REQUEST FOR EXCEPTION TO
RAPID CITY DESIGN STANDARD / CRITERIA / REGULATIONS

PROJECT Red Rock Shadows

EXCEPTION REQUESTED: SECTION 35.5316.16.010 STD / CRITERIA / REG Standard

Re: Request to waive the requirement to install 34' pavement and sewer main in Muirfield Drive.
Associated with Red Rock Shadows
City File # 17EX197, Related Files 14PL078

MUIRFIELD DRIVE EXHIBIT

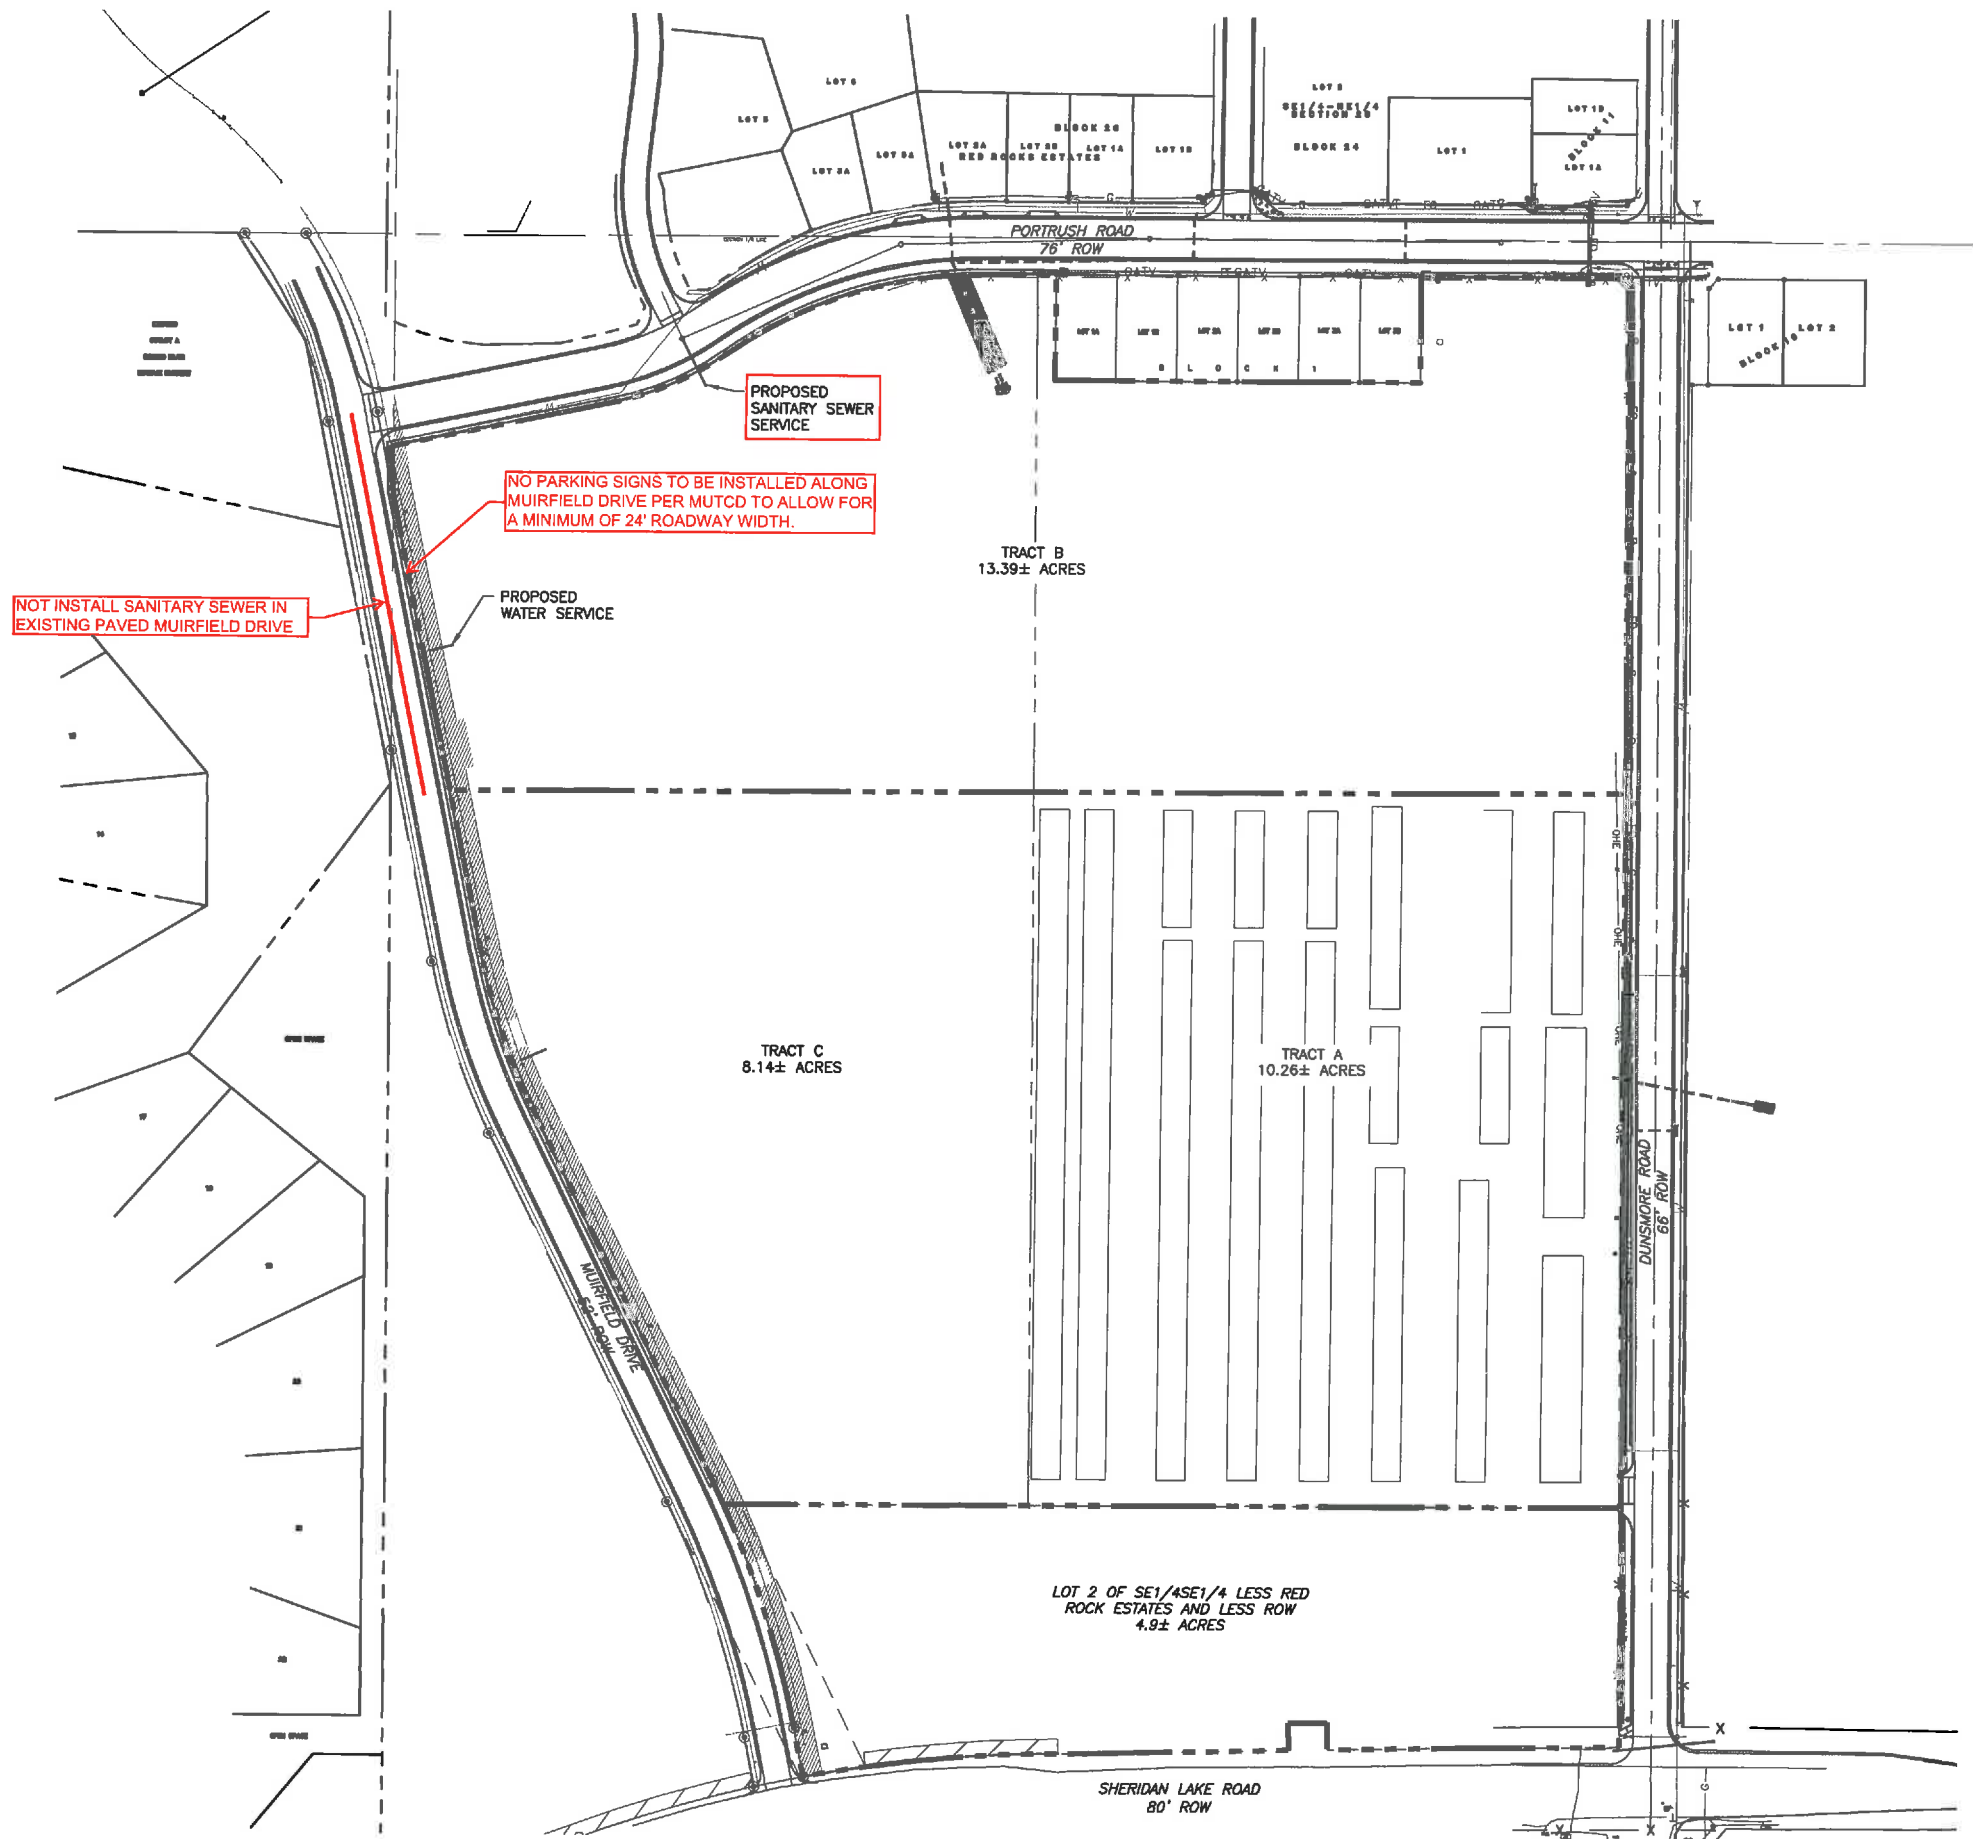
DESCRIPTION OF REQUEST: Waive the requirement to install 34 feet of pavement and sewermain along Muirfield Drive

JUSTIFICATION: No parking signs will be posted along Muirfield Drive to allow a min. 24' pavement width. Sewer will be provided to the parcel from an existing stub at the intersection of Portrush Road and Ainsdale Ct. - eliminating the need for additional sewer main.

The request to waive the requirement to install 34' of pavement in Muirfield Drive is approved. No parking signs must be provided by the developer on both sides of the street.

The request to waive the requirement to install sewer main in Muirfield Drive is denied.

For pavement, subdivision improvements including pavement, curb, gutter, sidewalk, street light conduit, water main and sewer main are triggered during the platting process for all adjacent roadways. The proposed Red Rock Shadows plat for Tract B has frontage to Muirfield Drive for approximately 360'. Muirfield Drive is a collector street on the City's Major Street Plan and is an existing improved right-of-way. The existing pavement width is 27', meeting the requirements for a collector street with no parking. The proposed plat is for a larger lot (13 acres) assumed to be for an MDR use, of which parking would be provided onsite. On street parking does not appear to be necessary adjacent to Tract B. No parking signs must be provided by the developer on both sides of Muirfield Drive.

For sewer, the Rapid City Infrastructure Design Criteria Manual Section 3.5.5 states "Sewer mains shall be extended across the full frontage of each parcel to be served, except... when the City determines that no possibility exists that the main will need to be extended to serve adjacent property." The adjacent properties along Muirfield Drive to the south on both the east and west sides of the road need sewer main extended in Muirfield Drive from the north in order to have gravity sewer service. Topography limits gravity sewer to coming from the north to serve this area. The developer is responsible to extend sewer across the full frontage of their property so that it is available to service neighboring properties. Therefore, sewer main needs to be extended with this project. The nearest sewer main is located in Muirfield Drive approximately 450' to the north of the northwest property corner so extension of sewer main only adjacent to proposed Tract B would construct a dry sewer main. As the developer owns land to the south that will need public sewer from Muirfield Drive, proposed Tract C, it is recommended that sewer be constructed to connect to the existing main in Muirfield Drive with this project making it an active

sewer main. It is assumed that sewer service for proposed Tract B would come from the existing main in Portrush Rd.
